APPLICATION NO.	FILING DATE	FIRST NAMED INVENTOR	ATTORNEY DOCKET NO.	CONFIRMATION NO.
10/597,506	10/05/2007	Masakazu Komatsu	0666.2940000	2138
	7590 02/04/201 SLER, GOLDSTEIN &	EXAMINER		
1100 NEW YO	RK AVENUE, N.W.	KNUTSON, JACOB D		
WASHINGTON, DC 20005			ART UNIT	PAPER NUMBER
			3611	
			MAIL DATE	DELIVERY MODE
			02/04/2010	PAPER

### **DETAILED ACTION**

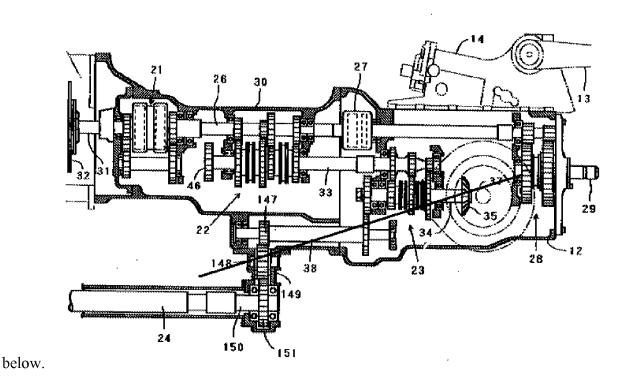
Applicant's arguments filed 9/4/09 have been fully considered but they are not persuasive. The applicant argues the prior art does not recite the limitation "the output shaft of the transmission casing and an input shaft of the gear casing are arranged on a same line and connected to each other". Furthermore, the applicant tries to argue the point by stating the output shaft and input shaft, as mentioned above, are arranged parallel to each other but on a separate parallel line. However, nowhere in the claim does it state the line has to be parallel to the output shaft and input shaft. It is further pointed out where a line exists between the output shaft and

input shaft in the image

Furthermore, the output shaft and input shaft are connected via gear 149, gear 147, and intermediate shaft 38.
